UNITED STATES PATENT AND TRADEMARK OFFICE

APPLICATION NO.	FILING DATE	FIRST NAMED INVENTOR	ATTORNEY DOCKET NO.	CONFIRMATION NO.
10/807,592	03/24/2004	Gregory C. Franke	200314727-1	3635

Office Action Summary

DETAILED ACTION

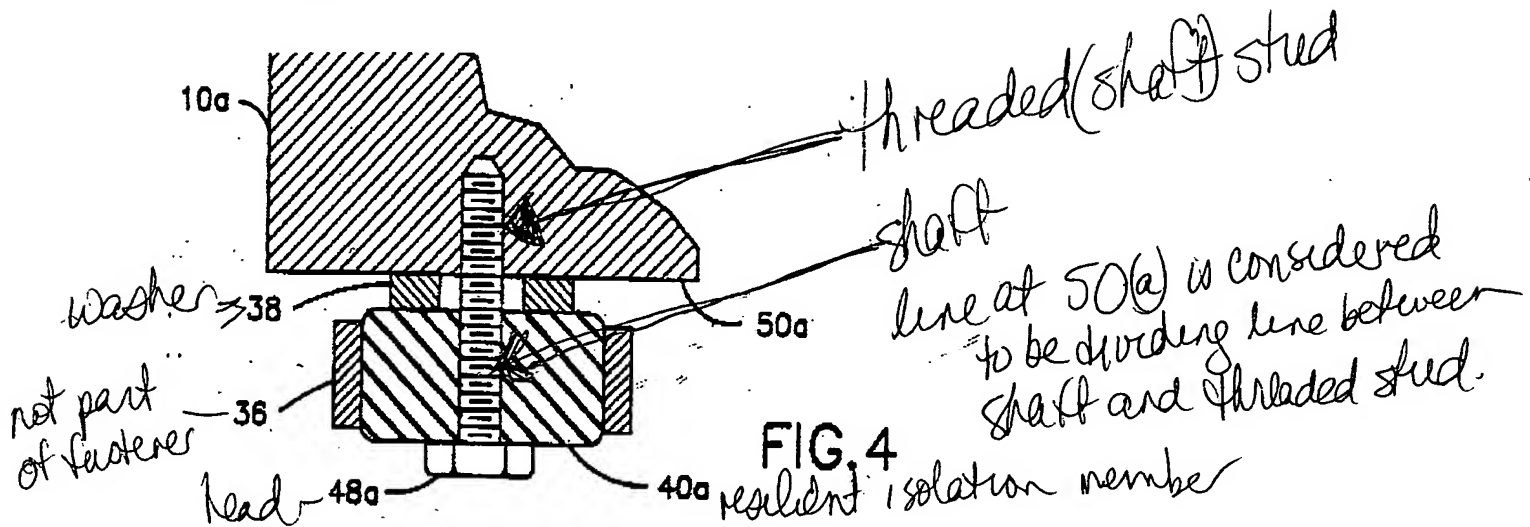
Felcman teaches a drive 40 with an outer housing 12 with slots (Fig 2A and 2B) and fasteners 50 mounted to the ends of the drive. However, the fasteners are not taught as having a resilient or elastomeric isolation member or having a washer mounted on the shaft between the head and stud. Grassens teaches fasteners with resilient isolation members in Figs 1 and 2, and col 2 lines 30-41 teach that resilient isolation members are well known to be used to absorb shock and vibrations for mounting electrical apparatus to a chassis, and col 2 lines 30-41 are specific that a washer can be used such that a resilient isolation member is provided on the washer between the washer and the head when the mounting surface is irregular or resilient. Note that "36" is NOT considered part of the Grassens fastener or the modified Felcman/Grassens fastener. The isolation member includes an outer wall and an axial portion. Were the fastener 50 of Felcman modified per Fig 4 of Grassens, (excluding "36" which would not be part of the modified fastener), the outer wall would be capable of abutting the drive cage surface and the axial portion would fit within the drive cage slot. The metal head, shaft, and threaded stud are a single unit (screw), and the threaded stud is considered the part as labeled below:

Washer 38 is in contact with the shaft via its contact with intermediate member 40a.

Absent any further limitation, the washer axial portion is approximately the same diameter as the outer head diameter. Examiner takes Official Notice that it is old and well known in the art to have resilient isolation members made of thermoplastic elastomers to dampen vibrations, and to have a fastener head selected from commonly used fastener heads to coordinate with existing drivers.
